### **COMMENTS TO REQUEST FOR REVIEW FOR THE MITIGATED NEGATIVE DECLARATION, LOWER PUTAH CREEK RESTORATION PROJECT, NISHIKAWA REACH, SCH#2015022022, SOLANO COUNTY**

Pursuant to the State Clearinghouse's 3 March 2023 request, the Central Valley Regional Water Quality Control Board (Central Valley Water Board) has reviewed the *Request for Review for the Mitigated Negative Declaration* for the Lower Putah Creek Restoration Project, Nishikawa Reach, located in Solano County.

Figure 1. Hydraulic Conductivity of Various Geologic Materials (CC BY-SA 4.0; Freeze, R. A., & Cherry, J. A, edited by Taryn Lausch, via [Wikimedia](#))

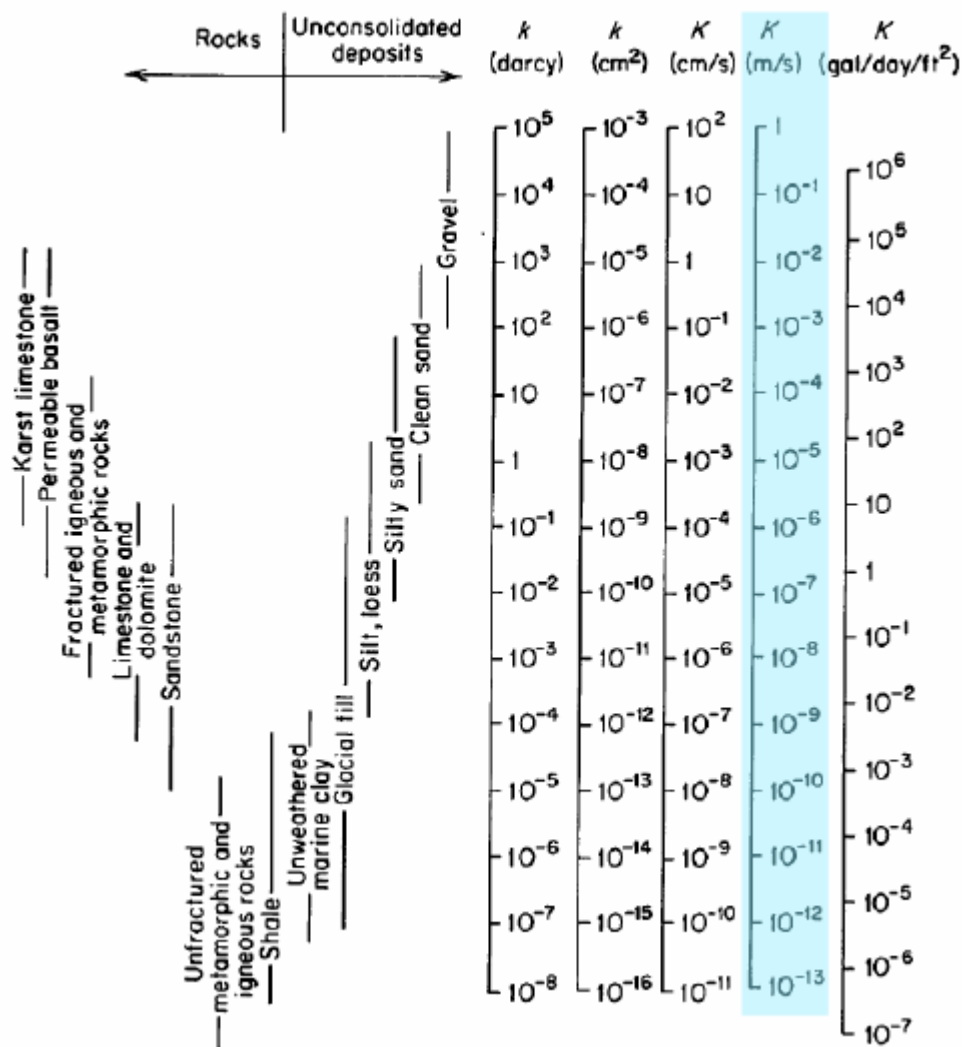
The rate of water flow through the deposits of granular materials follows Darcy's Law, where each sediment size or material has an empirical coefficient of permeability representing the ease of water flow through it. Water flow through clay is slow, and through gravels is fast. It is useful to consider the magnitude of difference in permeability that can exist between adjoining sediment layers in Putah Creek. For example, permeability ranges from  $10^{-7}$  m/s in silty sand to  $10^{-3}$  m/s in sandy gravel (Figure below). That is four orders of magnitude difference between layers that could easily be found one above the other in the floodplains of Putah Creek. To put it in context, a one square foot cross-section unit of the sandy gravel in the stream bank or

floodplain has the potential to allow as much groundwater flow as a 10,000 square foot cross section of silty sand.

Clearly sorting and layering matters tremendously.

*Figure 3. Remnant cottonwoods that died after Phase 1 of WPCP project.*

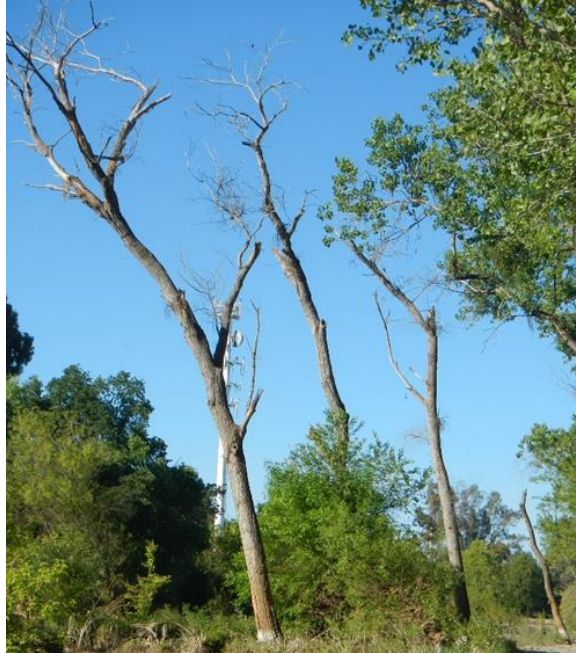
Like the proposed Nishikawa Project, the Winters Project began with near total clearing of the floodplain, destroying a mature and mostly native riparian forest. A handful of mature native trees were spared, some perched on pedestals, others having endured heavy traffic pounding over the root zone. In subsequent years, the remnant mature trees spared in the Project died as a result of the project.

Figure 6. Groundwater Levels, Martinez Well, near Winters Putah Creek Park. Blue line indicates implementation date of Winters Project and the beginning of groundwater decline.

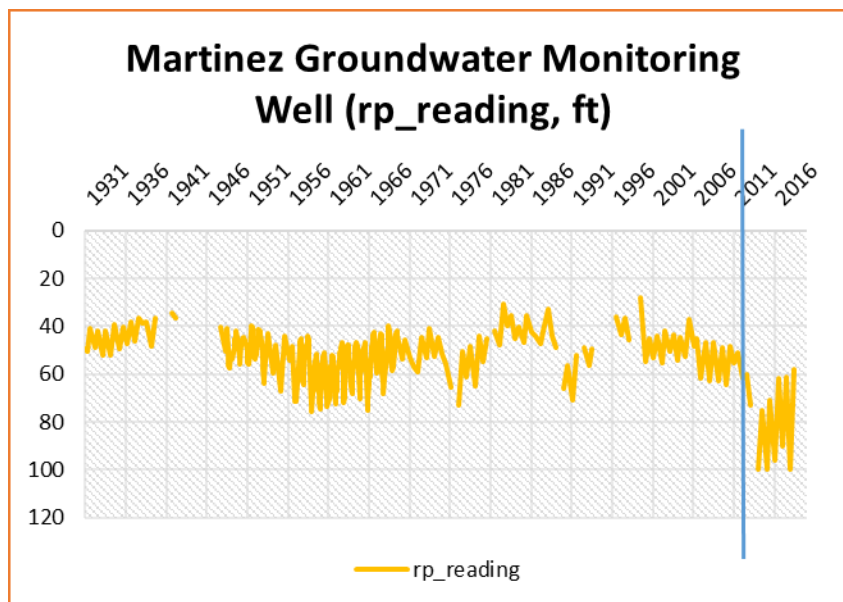
There is a groundwater monitoring well located about 200 feet away from the creek and directly across from the WPCP and SCWA's projects there. The data go back to 1931. What the groundwater elevation data show is a significant drop in water levels subsequent to the

implementation of SCWA's projects in 2011. This suggests that there was a drop in groundwater recharge due the WPCP project in 2011.

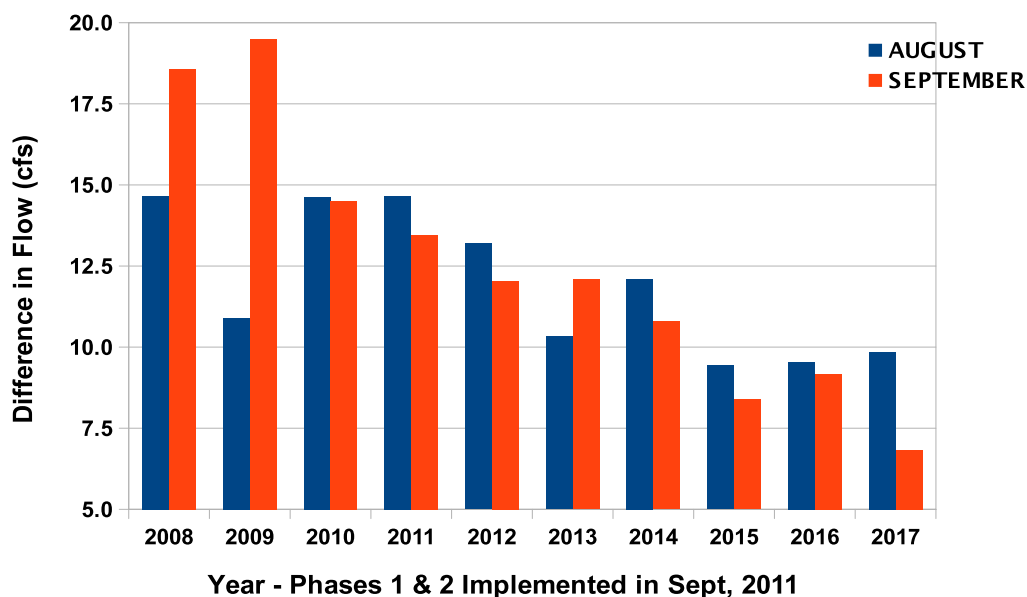
8. Stream Gauge Data. Stream gauge data gives incontestable evidence of ground water recharge effects. The gauge data is reliable and quantitative, and confirms all the other lines of evidence. FOPC obtained the gauge data from SCWA for the water years 2008 to 2017. FOPC analyzed the data for the months of August and September when irrigation withdrawals are not permitted and rainfall and runoff are non-existent. FOPC looked at the loss of stream flow in the reach with the Phase I-II projects, between a gauge at the SCWA diversion dam and I-505. The measured loss of stream water is approximately equal to water that is going into groundwater recharge. A small part is due to evaporation from the stream and transpiration from the floodplain vegetation, but that remains constant between pre and post-project years. Any decline in water loss between pre and post-project years is therefore attributable to project impact on reducing groundwater recharge.

9. What the data show (Figures 1 & 2) are that the Phase I-II projects reduced the amount of stream water going into groundwater recharge by an average of 5.6 cfs. This is based on comparing the monthly average water loss pre and post the project implementation. To put this in perspective, 5.6 cfs on an annual basis is equal to 4,054 acre feet, about 2.7 times the total annual water use in the City of Winters, or enough to irrigate 1,350 acres of almonds.

13. Figure 3 – Groundwater Monitoring Well – Martinez Ranch. After the Phase I and II projects in 2011, groundwater levels in a monitoring well (within several hundred feet) dropped to historic lows.

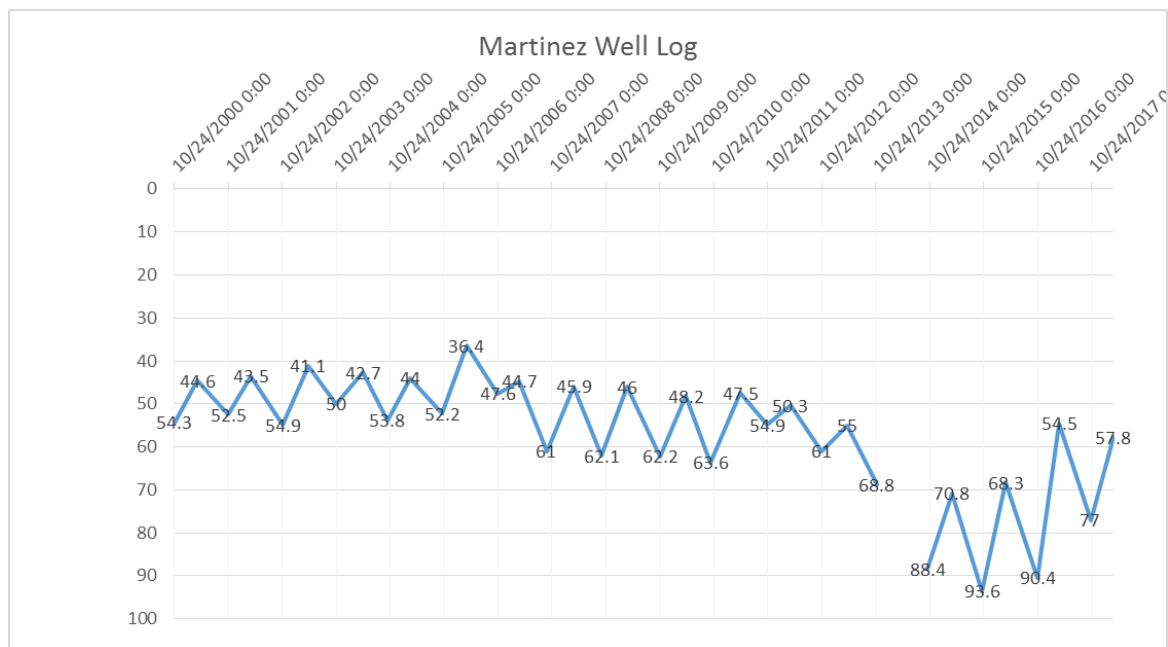
12. Monitoring Well Data. The effect of the decrease groundwater recharge is in evidence in the data from a groundwater monitoring well that is within several hundred feet from the Phase I-II projects on the Martinez Ranch. What the groundwater well data shows is a serious decline in groundwater levels that began concurrently with the Phase I-II projects (Figure 3).

While all the data is not shown, the lows of the last four years are below any other lows recorded since 1930.

Figure 1. Invasive Plants in Nishikawa Project Area

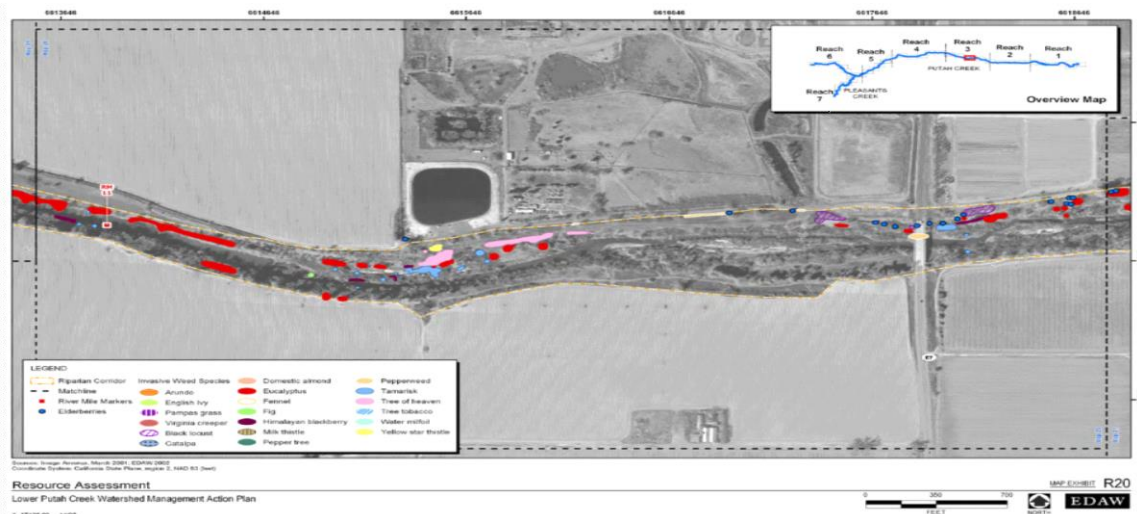
Also note that most of the project area is free of invasive plants and does not need to be disturbed for their management as shown in the following figure from the Lower Putah Creek Watershed Management Action Plan.

*Figure 3. 2019 Fish Counts*

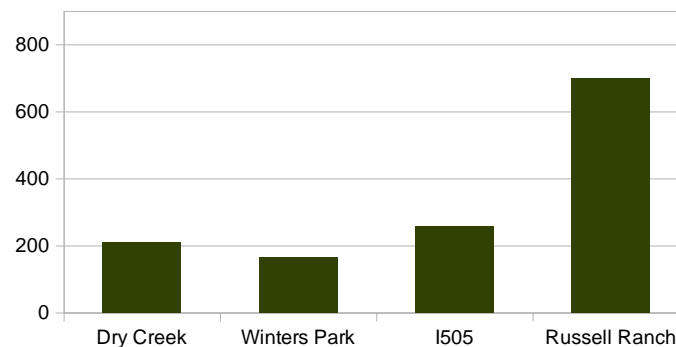
**2. Decrease in native fish and other wildlife populations.** Native fish populations have declined in Winters Putah Creek Park over the past decade instead of gaining which was the whole intent of that project. Native fish counts in the Winters Putah Creek Park are typically less than in immediate upstream and downstream reaches of the Creek

*Figure 4. 2020 Juvenile Salmon Counts*

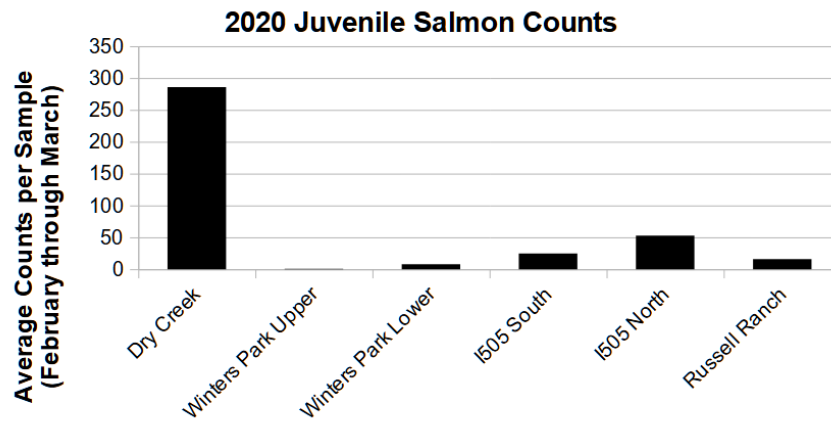
Narrowing and reducing stream size likewise reduces in-stream habitat for fish – especially for small fry. Altering channels destroys undercut banks and replaces them with out-sloped banks lacking in cover for fish and this is reflected in the small number of salmon fry in the Winters Putah Creek Park compared to both upstream and downstream creek reaches.

*Figure 9. Groundwater Levels, Martinez Well, near Winters Putah Creek Park. Blue line indicates implementation date of Winters Project and the beginning of groundwater decline.*

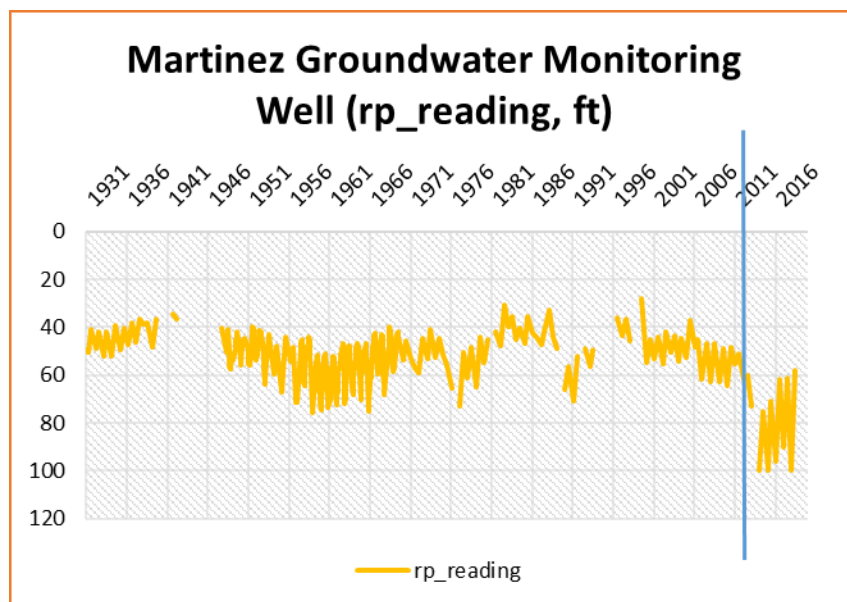
The further result is a very significant drop (4000 acre feet annually) in groundwater recharge, evidenced by falling groundwater levels in a nearby monitoring well (Figure 9), and by stream gauge data that clearly shows a decrease in water loss from the stream. Finally, in 2017 SCWA investigated groundwater levels by digging a set of trenches which revealed groundwater levels had fallen more than 8 feet below the surface just 10 feet from the stream bank.

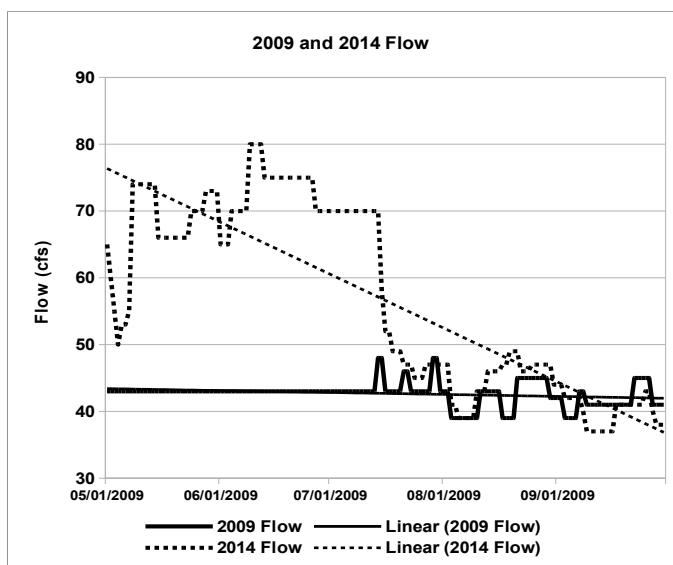
As shown, the mean daily temperature differential between Winters Bridge and Stevenson Bridge site was approximately 0.25 – 0.5 deg C lower from April 1 to July 15 in 2014 (post-project) compared to 2009 (pre-project); albeit with large daily fluctuations. Beginning in August the mean temperature differential was not statistically different between 2009 and 2014.

### Putah Creek Total Fish Counts Sampled at Russel Ranch 2013 - 2020

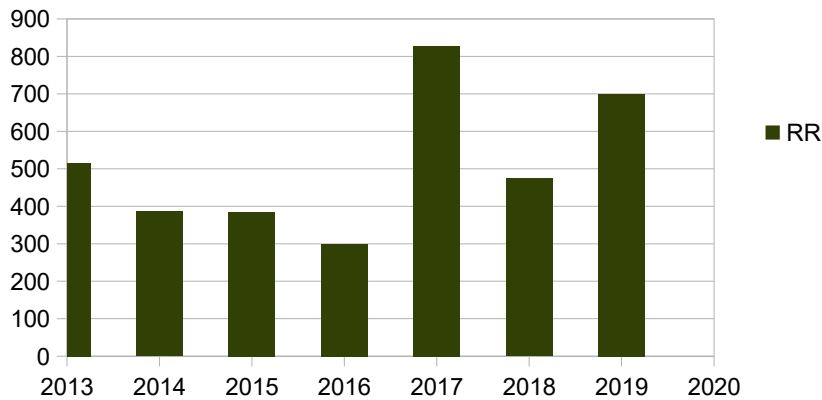
These graphs conclusively demonstrate that in almost every year since construction of the Winters Putah Creek Park project, total fish populations in the Winters Putah Creek Park project and immediately downstream at I505 are, on average, severely depressed compared to fish counts made immediately upstream at Dry Creek and further downstream at Russell Ranch. This substantial evidence negates the claim that drastic geomorphological engineering can beneficially impacts fish populations by narrowing the channel as claimed by project proponents.

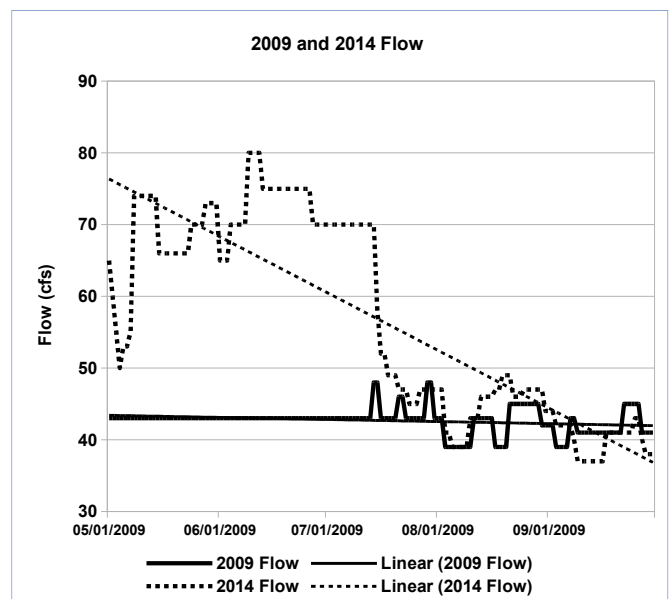
SCWA engineers have stated that these decreased temperature differential spreads between these two sites, at least in May - early July of 2014 compared to 2009, is “compelling” evidence supporting their thesis that the Winters Putah Creek Park rechannelization project is producing cooler downstream temperatures.

*We strongly disagree with their conclusions.*
